Changes to proposed District Map Amendment G-956

On May 2, the Planning Board transmitted to the County Council proposed Zoning Text Amendment (ZTA) 13-04, Zoning Ordinance – Revised, and District Map Amendment (DMA) G-956. DMA G-956 was introduced to implement the new zoning ordinance.

A revised version of DMA G-956, dated October 11, 2013, has been posted on the Planning Department website for review. It contains all of the proposed and approved changes that have occurred since August 30, 2013. The following document illustrates all of the changes to DMA G-956.

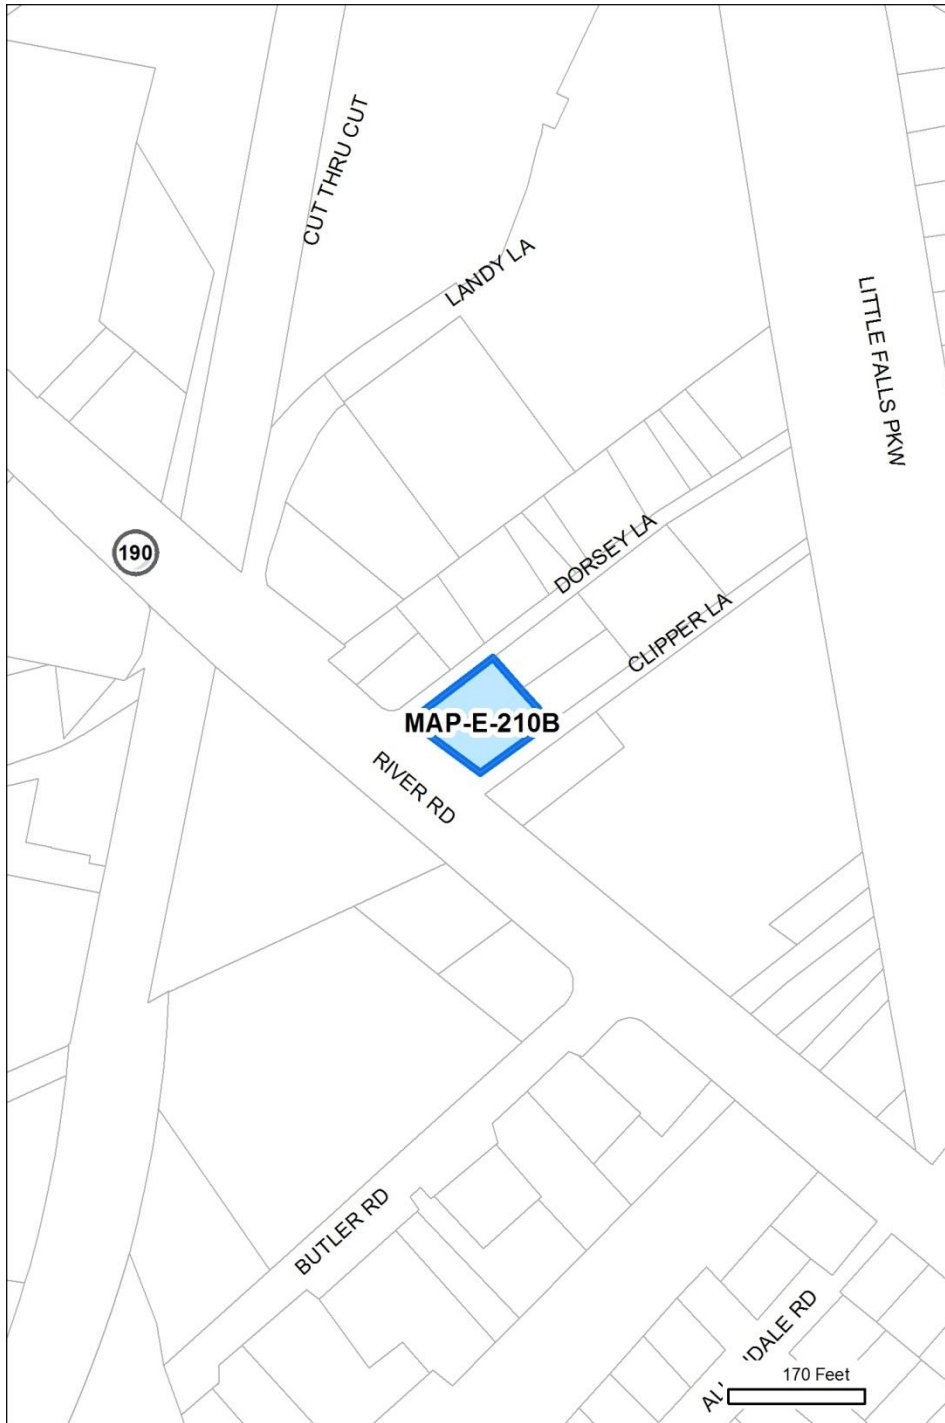
Unique ID: MAP-E-210A		staff error
Master Plan ID: n/a		
Master Plan:	Westbard	
Location:	Westbard Ave @ Westbard Cir	
Existing Zone:	C-O	
Proposed Conv: (8/31)	EOF-3.0 H-100	
Prop. Revised Conv:	EOF-1.5 H-45	
Category:	Staff Error	
Modifications	Zone Group:	No change
	Overall FAR:	Reduced to 1.5
	Comm'l FAR:	-
	Resid'l FAR:	-
	Height:	Reduced to 45
Reason for change:		
<p><i>The Westbard Sector Plan calls for lower density and height in the C-O zone in this area.</i></p> <p><i>As a result, the proposed conversion for this property should be lower in intensity and height.</i></p>

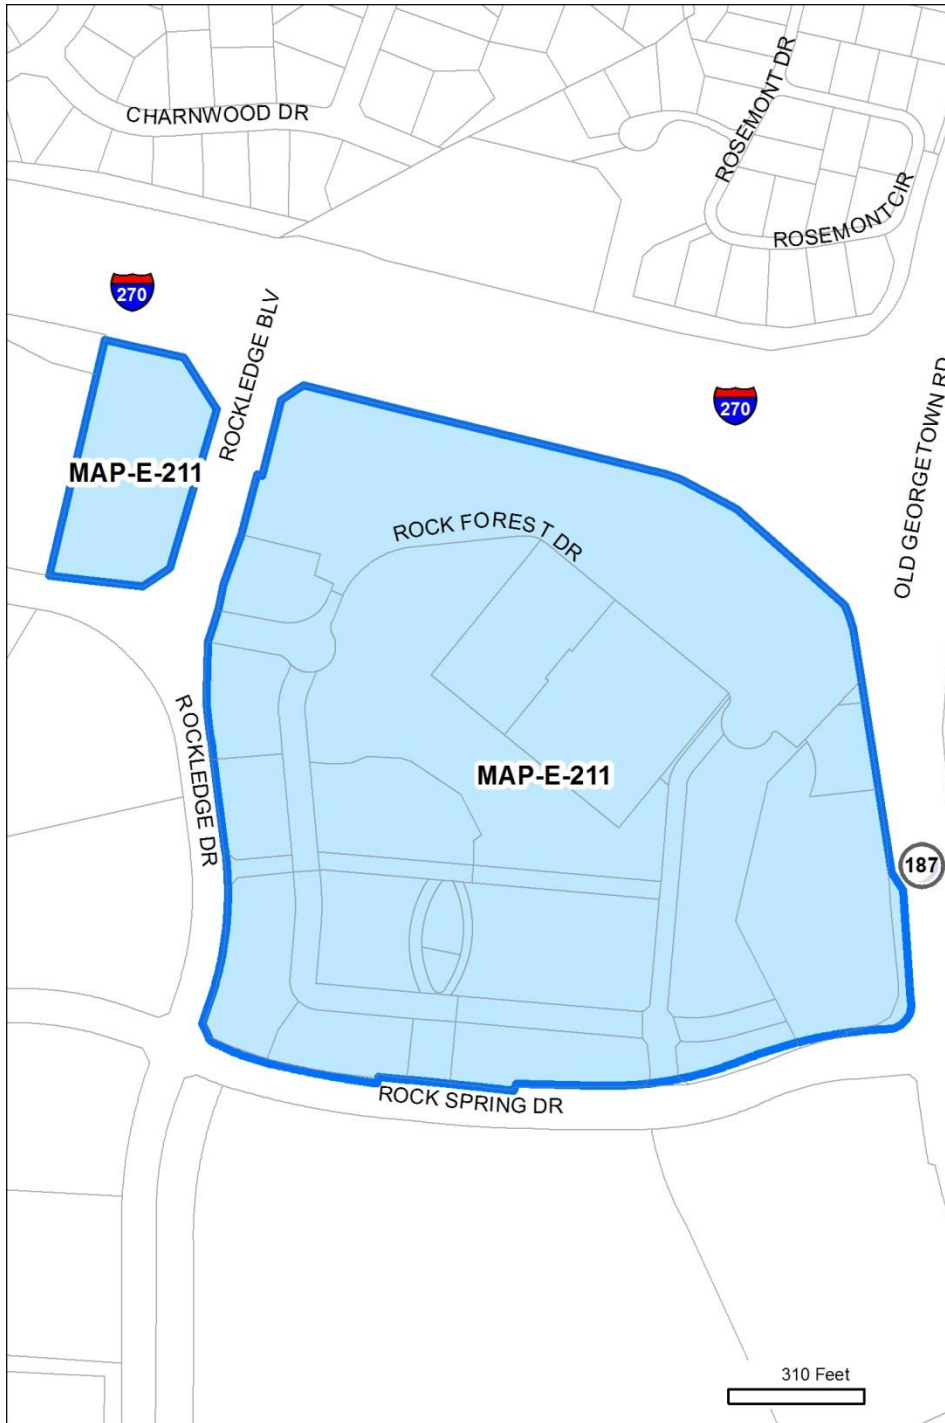
Unique ID: MAP-E-210C		staff error
Master Plan ID: n/a		
Master Plan:	Westbard	
Location:	River Road @ Ridgefield Rd	
Existing Zone:	C-O	
Proposed Conv: (8/31)	EOF-3.0 H-100	
Prop. Revised Conv:	EOF-1.5 H-45	
Category:	Staff Error	
Modifications	Zone Group:	No change
	Overall FAR:	Reduced to 1.5
	Comm'l FAR:	-
	Resid'l FAR:	-
	Height:	Reduced to 45
Reason for change:		
<p><i>The Westbard Sector Plan calls for lower density and height in the C-O zone in this area.</i></p> <p><i>As a result, the proposed conversion for this property should be lower in intensity and height.</i></p>

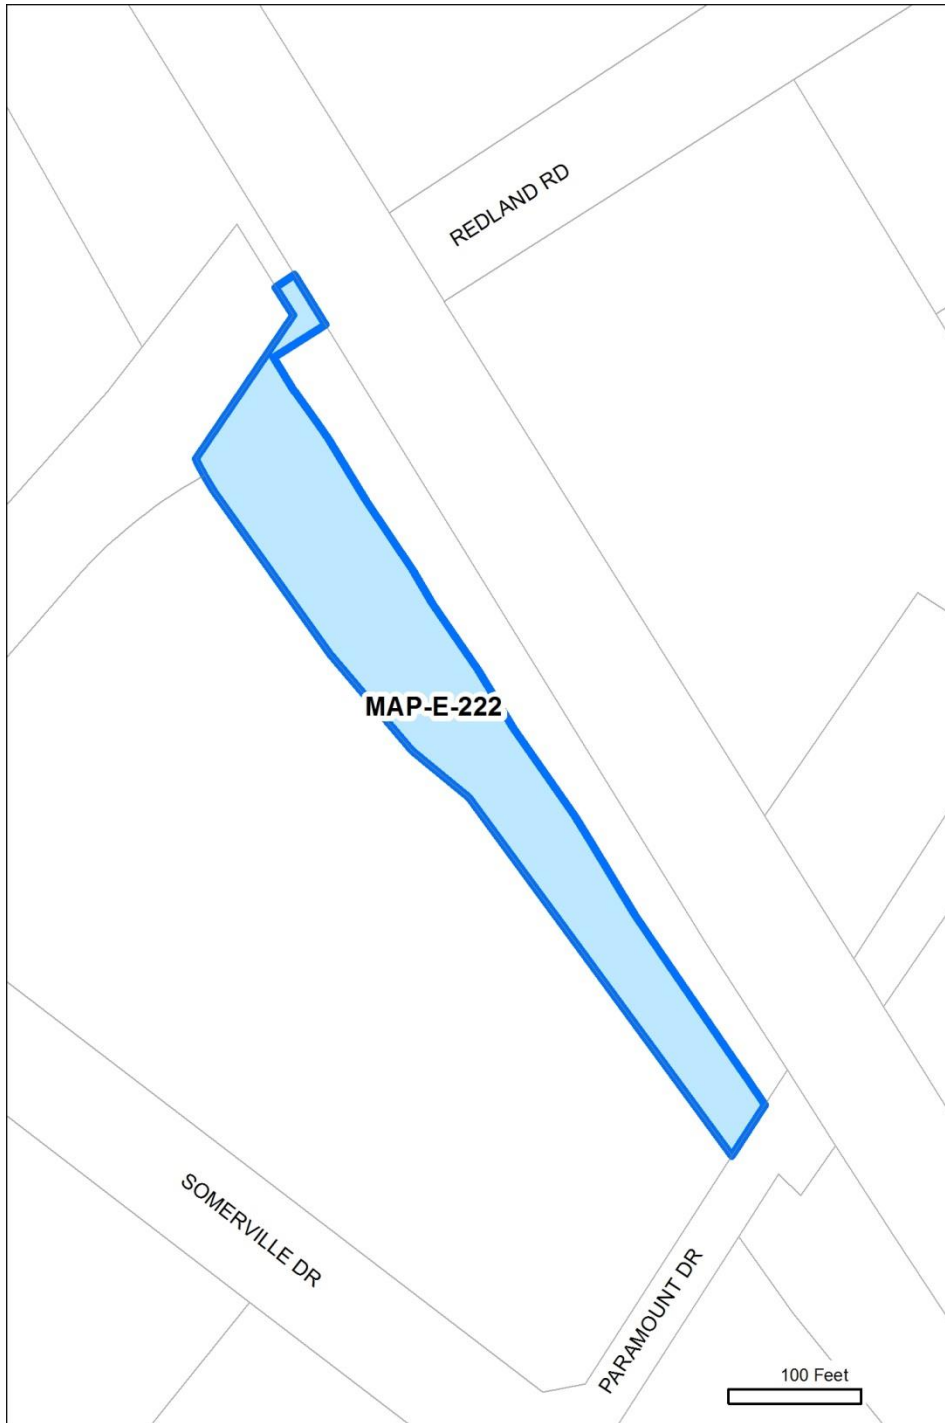
Unique ID: MAP-E-211		staff error
Master Plan ID: 2		
Master Plan:	North Bethesda/Garrett Park	
Location:	Rockledge	
Existing Zone:	MXPD	
Proposed Conv: (8/31)	CR-1.25 C-0.5 R-0.75 H-275 T	
Prop. Revised Conv:	CR-1.5 C-0.75 R-0.75 H-275 T	
Category:	Staff Error	
Modifications	Zone Group:	No change
	Overall FAR:	Increased to 1.5
	Comm'l FAR:	Increased to 0.75
	Resid'l FAR:	No change
	Height:	No change
Reason for change:		
<p><i>Planning Staff created the proposed translation for this property based on the development approved for the site. However, because institutional uses fall under the non-residential cap (59-C-7.54), the proposed commercial density was not high enough to accommodate the approved development.</i></p> <p><i>As a result, the overall and commercial FARs have been increased to better match the approved development for this site.</i></p>

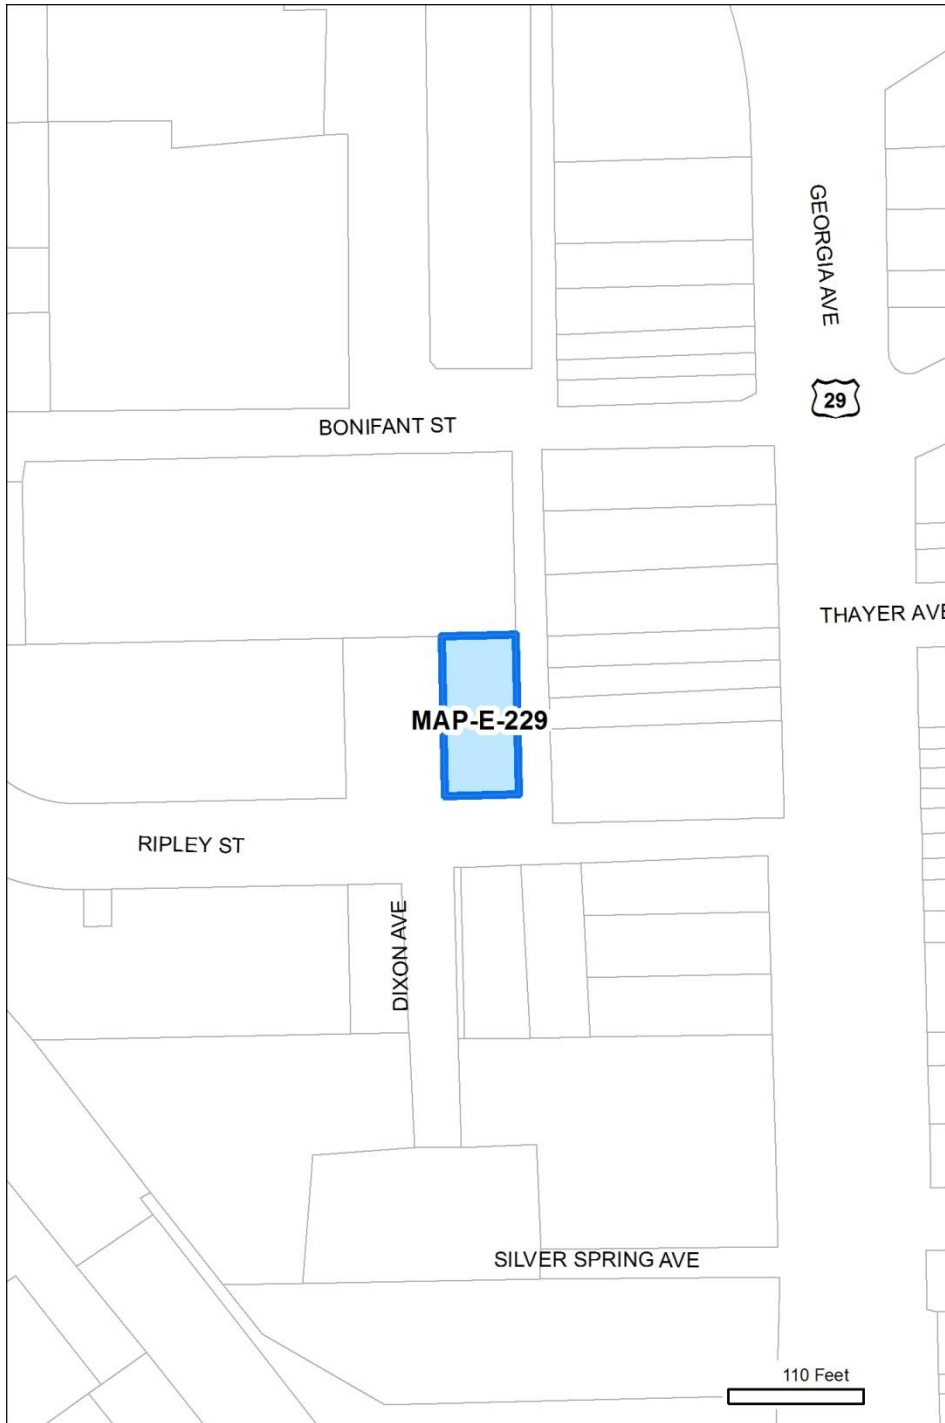
Unique ID: MAP-E-222		staff error
Master Plan ID: n/a		
Master Plan:	Shady Grove	
Location:	Along Metro tracks, N of Paramount Dr	
Existing Zone:	R-90	
Proposed Conv: (8/31)	R-90 + TDR-60	
Prop. Revised Conv:	R-90	
Category:	Staff Error	
Modifications	Zone Group:	No change
	Overall FAR:	-
	Comm'l FAR:	-
	Resid'l FAR:	-
	Height:	-
Reason for change:		
<p><i>This parcel was shown on the 8/31 DMA map as R-90 + TDR-60, however the TDR receiving area should only be limited to the adjacent MXPDP/TDR-60 zone.</i></p> <p><i>This change moves the TDR-60 Receiving Overlay line to the appropriate location, matching the current MXPDP / R-90 boundary.</i></p>
